## Responses to RC1

The study from Hu et al. entitled ‘Modelling rock glacier velocity and ice content, Khumbu and Lhotse Valleys, Nepal’ proposes a model to infer rock glacier ice content based on InSAR velocity measurements. The model is calibrated based on the observational data of the Chilean Las Libres rock glaciers and validated using data from four rock glaciers in the Alps, before to be applied in NE Nepal. The objective is to estimate the water storage of the rock glaciers at the regional scale.

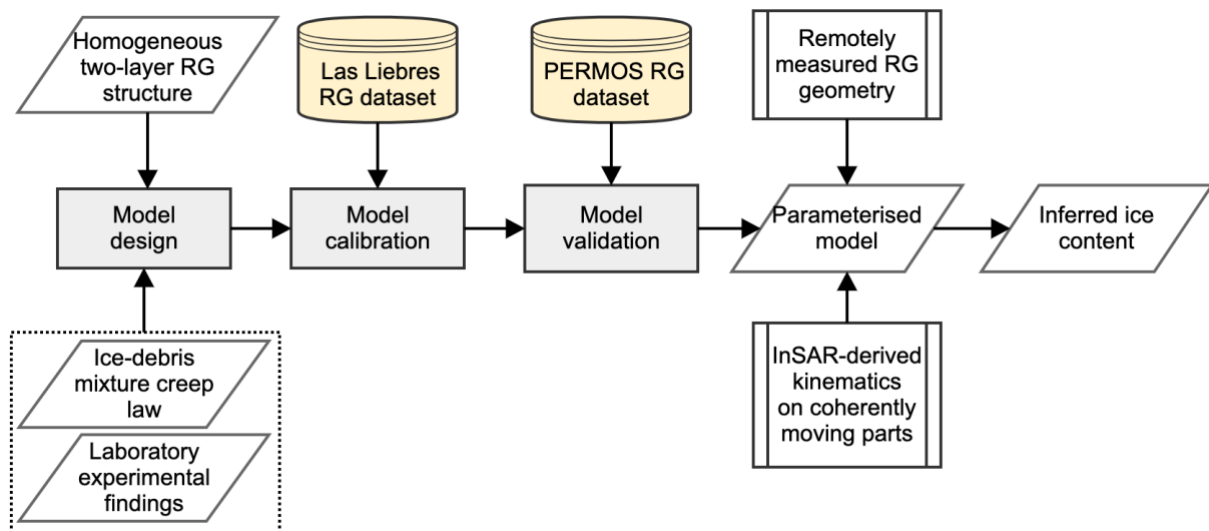
Figure 2: As I understood, you just used the coherent part as input to the model, so it may be enough to write 'InSAR-derived kinematics on coherently moving parts'.

Re: We have changed the notes of this figure.

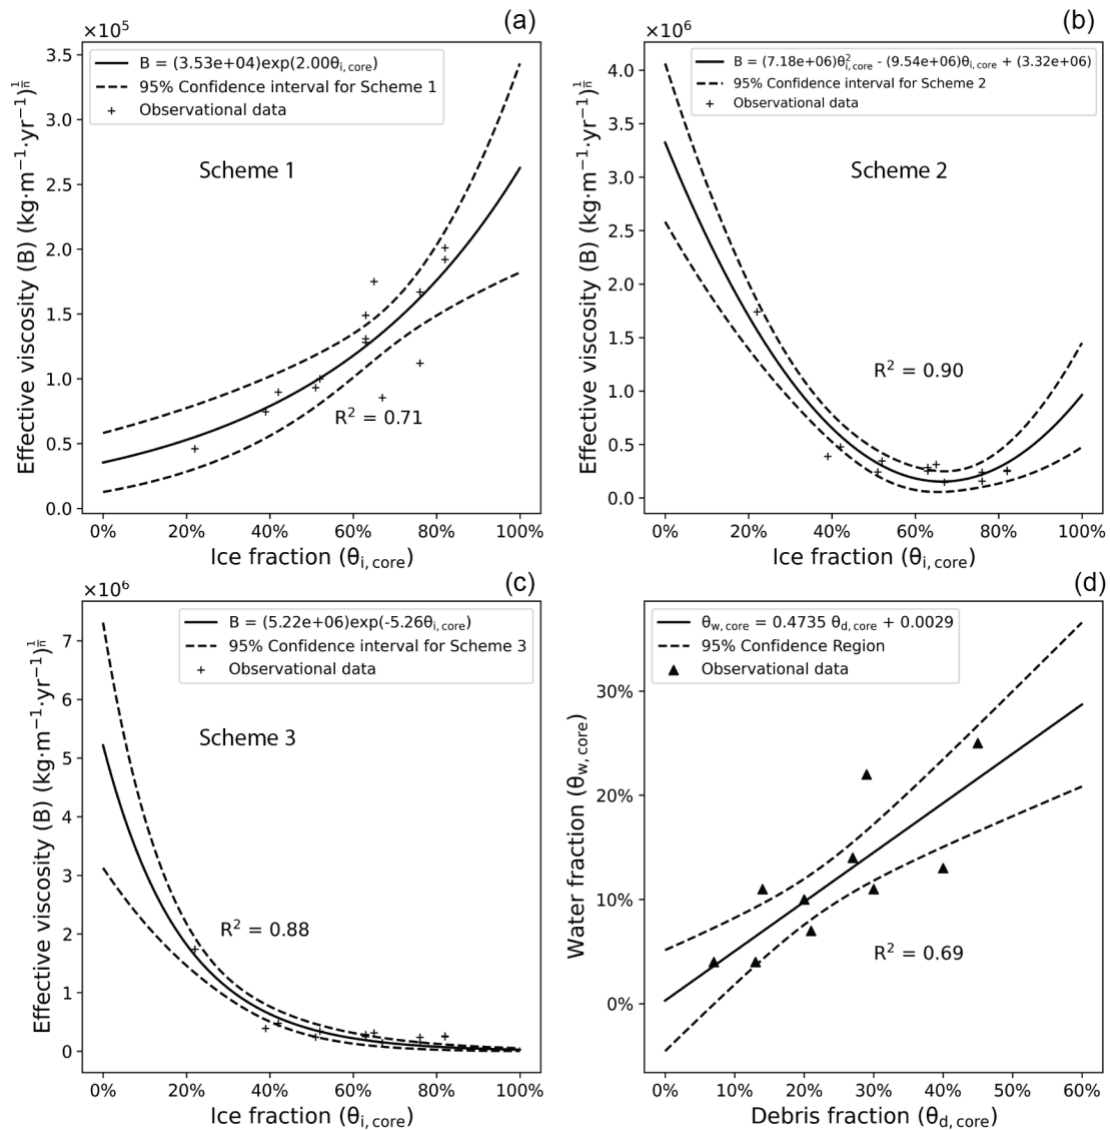
Figure 4: It could be moved to Results. Also, since you numbered the Schemes 1-2-3, it would be good to label the subplots a)-c) accordingly, by adding subtitles to make it easy to understand.

Re: We have labeled the subplots according to this comment.

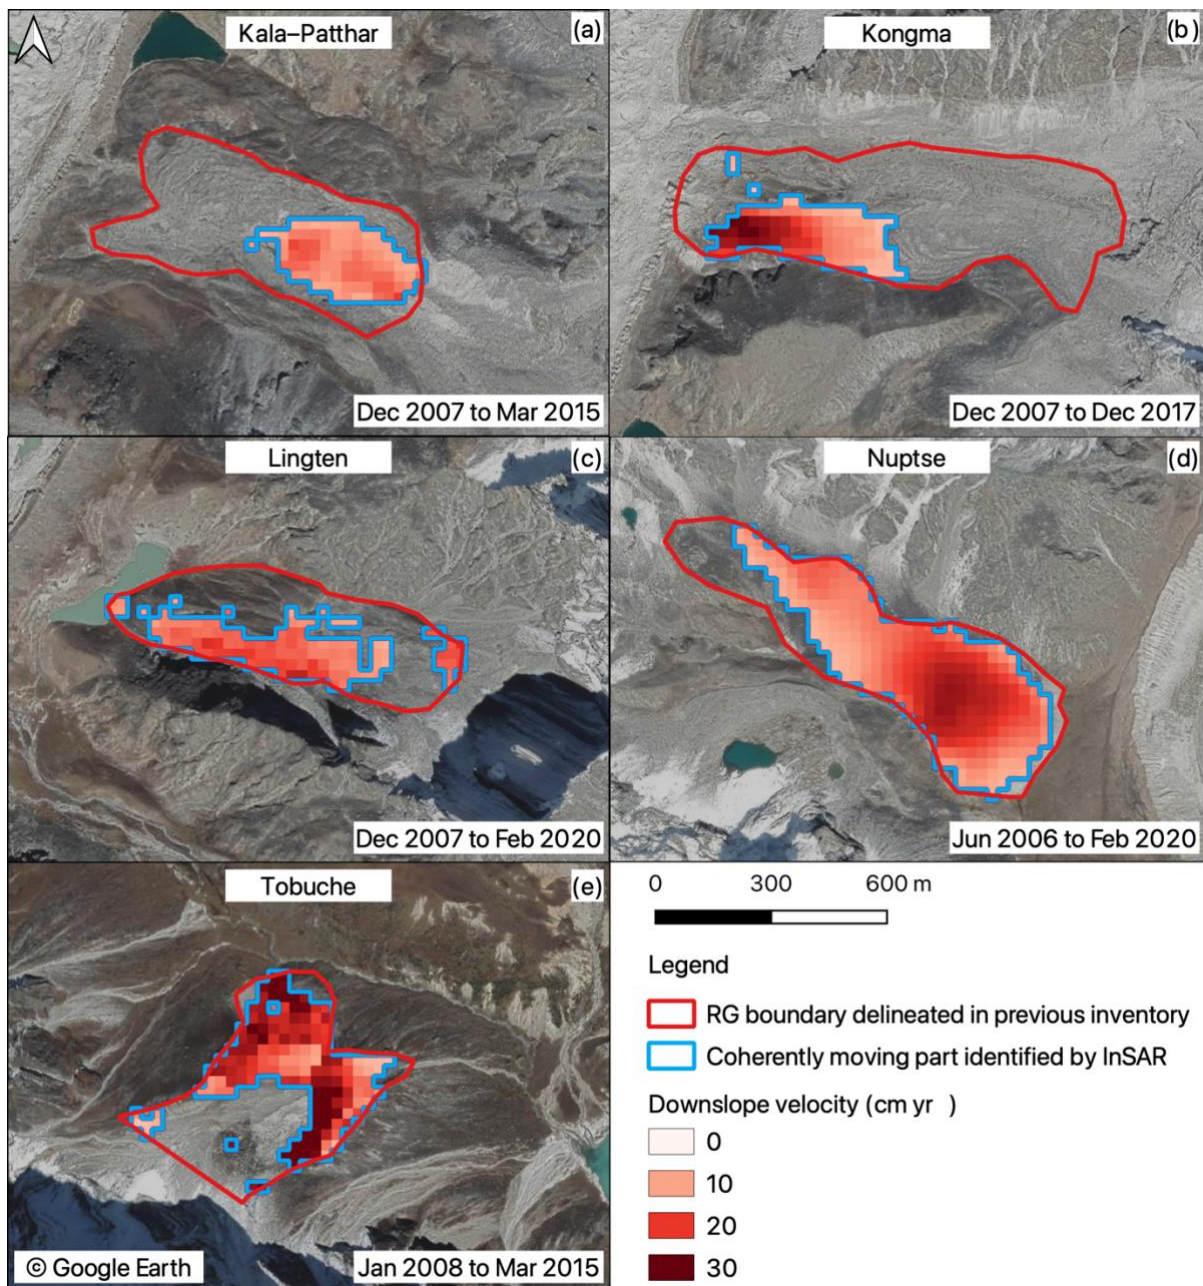
Figure 6: Missing scales.

Re: We have added a scale to Fig. 6.
